**HISTORIC ARCHITECTURAL REVIEW BOARD
CITY OF ALLENTOWN, PENNSYLVANIA
June 25, 2018
MINUTES**

ITEM #1 – Case #HDC-2018-00019– Proposal to install 3 security cameras

ITEM #1 – Case #HDC-2018-00023– Proposal to continue the installation of new stucco on side of house.

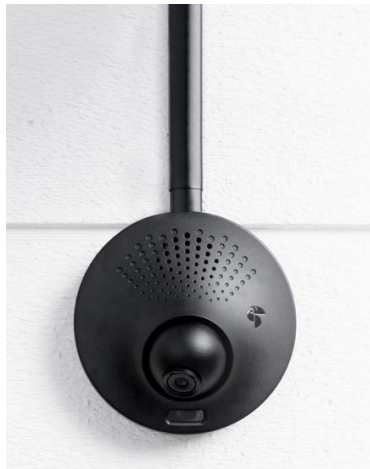
Evaluation, effect on historic district, recommendations: The proposed security cameras could be historically appropriate given more detail on the exact model and installation method. It appears a suggestion of disguising the camera with some sort of decoration is proposed; this should be confirmed, and addressed as to whether this is an appropriate way to 'hide' a camera that is otherwise in plain view. There are some products out there that better hide cameras utilizing outdoor lighting, though their effectiveness for a multi-family rental may be complicated by the fact that many of these products rely on apps and cell phones, but it could be worth looking into. Specifically, the company Kuna has several options, including cameras already incorporated with wall lights, or cameras that can be hooked into existing light fixtures:

Discussion: Discussion of this project was difficult without the attendance of the applicant for the second month and without sufficient information to understand what was proposed for the security camera installation. One of the images in the application showed security cameras camouflaged with an eagle and mounted between shutters. It was determined that this was not on the applicant's building. The consensus of the HARB was this was not an appropriate installation. One of the HARB members said some cameras had been installed on buildings at the rear of the property already. They had exposed conduit above windows. The HARB agreed that wiring with exposed conduit did not meet the Design Guidelines and was not appropriate. It was concluded that the project would need to be denied because of insufficient information

about the exact appearance of the cameras and the lack of information on how they would be wired and mounted. The HARB also thought the locations indicated were too visible and that alternates needed to be considered.

1. The proposal to install 3 security cameras at 245 N 9th Street was not represented.
2. The case was denied due to the lack of representation and lack of information
3. The information missing in the application includes the exact appearance and how they will be wired and installed on the facades.
4. According the Design Guidelines for the Historic District security cameras should be mounted on secondary facades in an unobtrusive location or painted to minimize their visual impact.
5. The locations indicated for the cameras were highly visible and did not meet the Design Guidelines.

Motion: The HARB upon motion by Mr. Fillman and seconded by Ms. Roberts adopted the proposal that City Council DENY a Certificate of Appropriateness for the proposed work described herein:
